# CITY OF ALBUQUERQUE

Planning Department  
Alan Varela, Director

**RE: 6432 Dennison Rd SW**  
**Grading and Drainage Plan**  
**Engineer's Stamp Date: 03/21/22**  
**Hydrology File: K11D090**

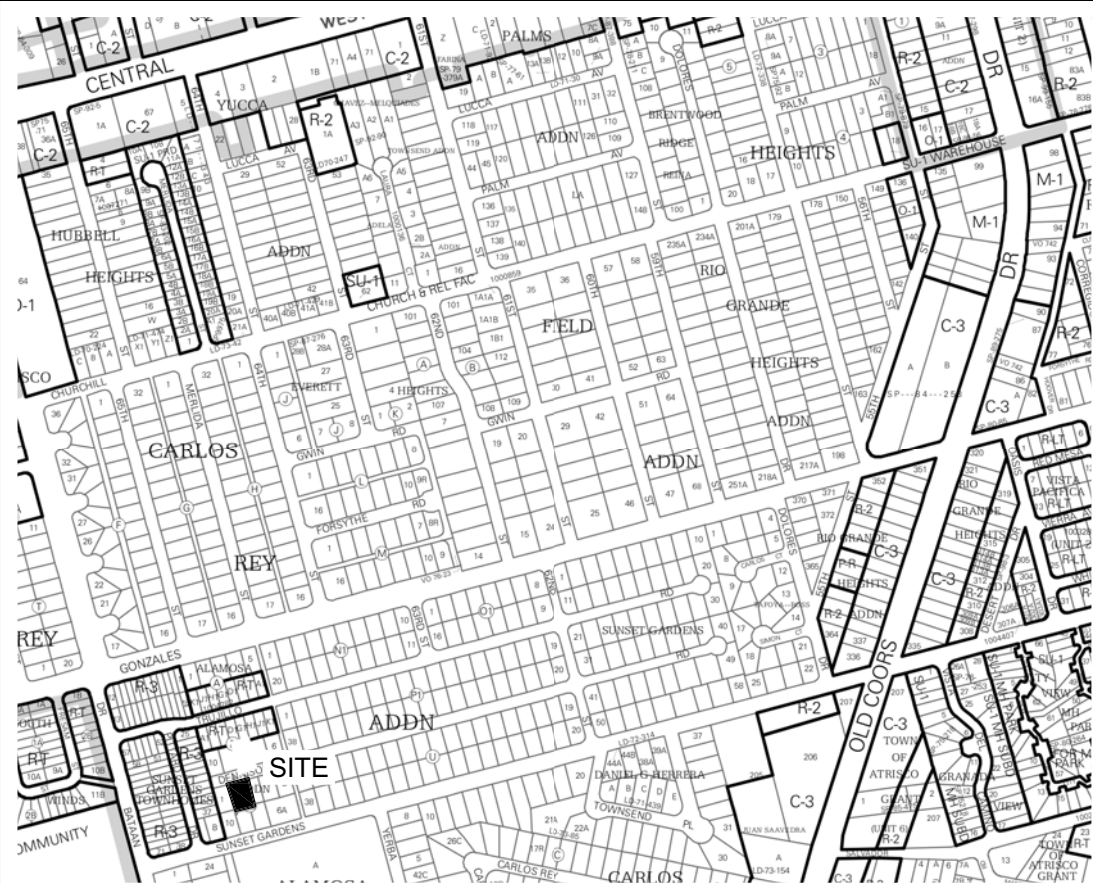
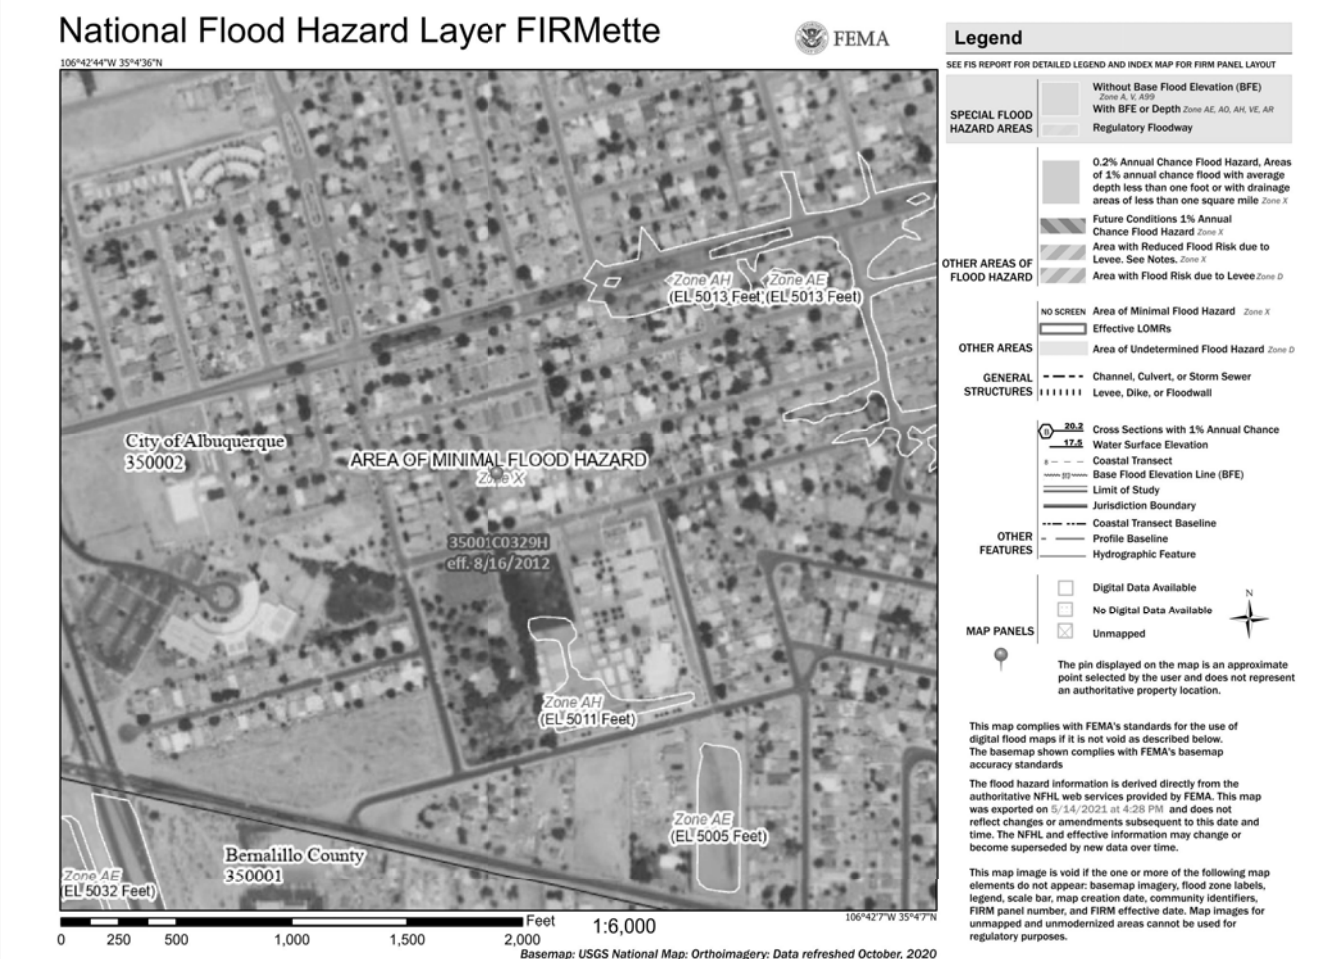
Based upon the information provided in your submittal received 03/22/2022, the Grading and Drainage Plan is approved for Building Permit and Grading Permit. Since this site is relatively flat and grades to the road, a pad certification is not needed for this project. Please attach a copy of this approved plan in the construction sets for Building Permit processing along with a copy of this letter.

1. Engineer's Certification, per the DPM Part 6-14 (F): Engineer's Certification Checklist For Non-Subdivision is required.
